**RE: Lot 22 Block 1 Volcano Cliffs Unit 22 SAD 228
8008 Agua Fria Ct. NW
Grading and Drainage Plan
Engineers Stamp Date: 10/29/2020 (D10D003N22)
Pad Certification Date: 5/10/21**

SHEET TITLE:
GRADING AND
DRAINAGE PLAN

SUBMITTED FOR:
PAD CERTIFICATION

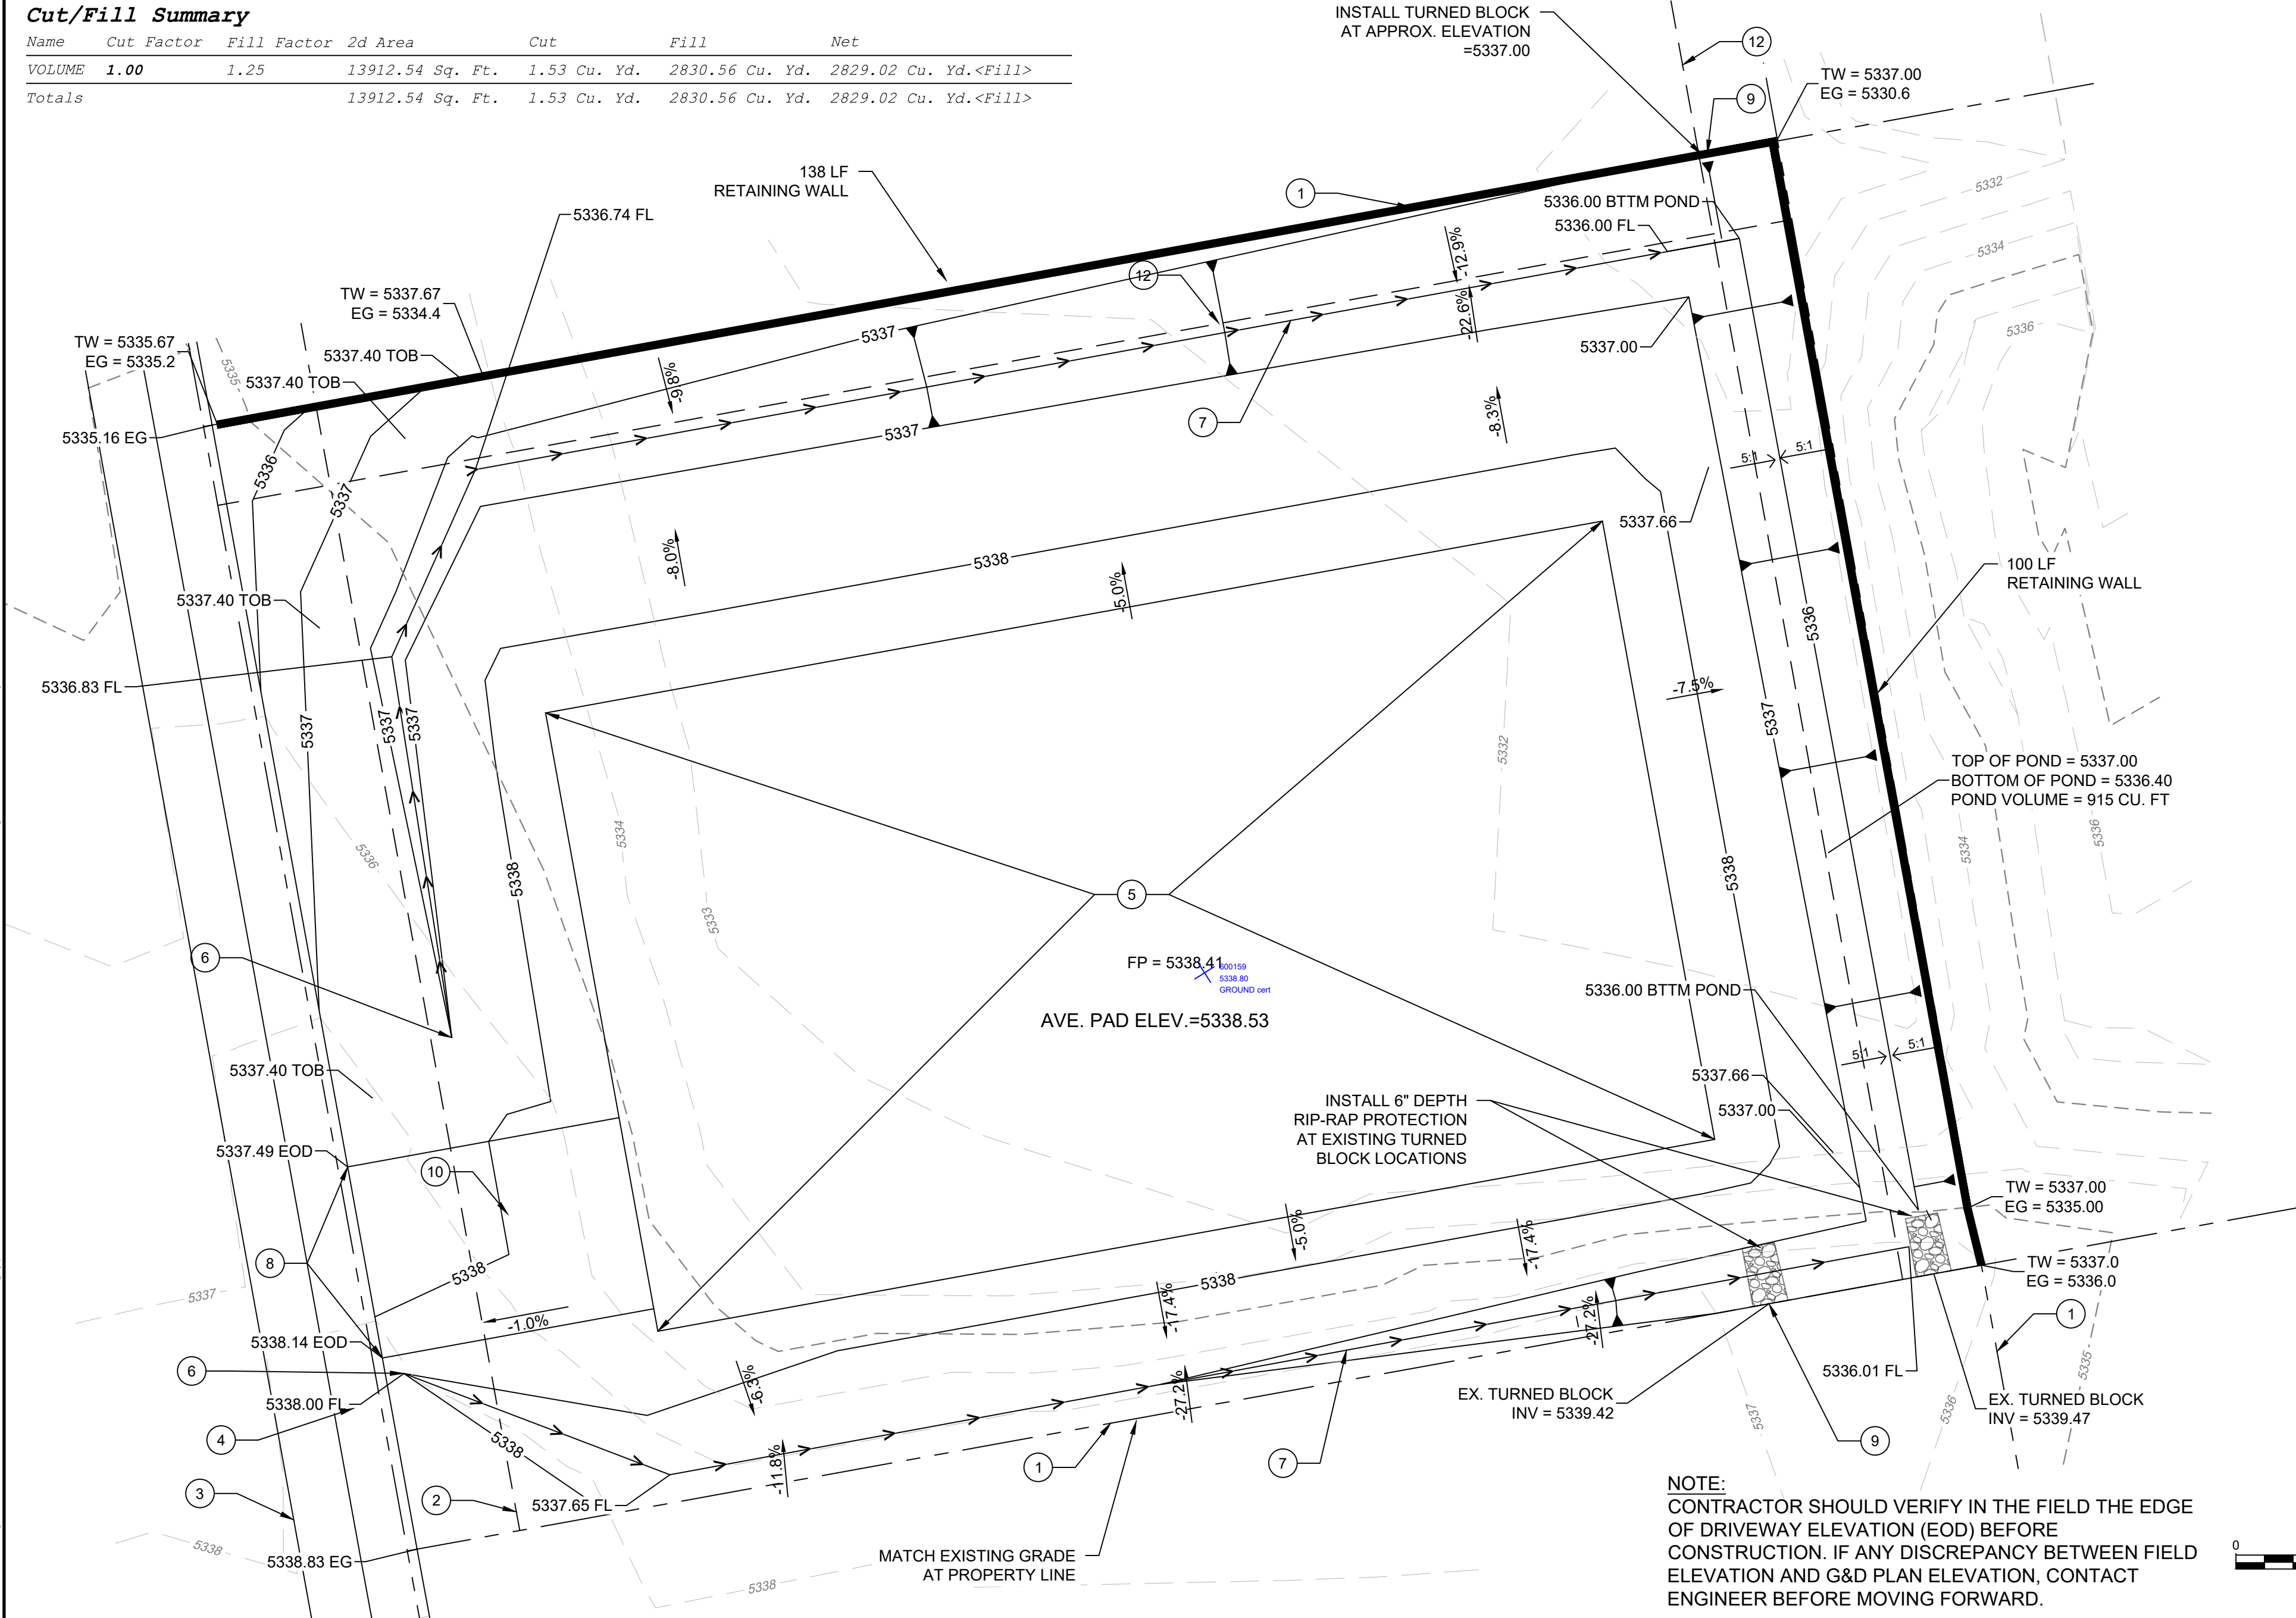
Based upon the information provided in your submittal received 5/14/2021, this plan cannot be approved for Grading Permit until the following comments are addressed.

- Provide the approval letter or email given by Doug Hughes.
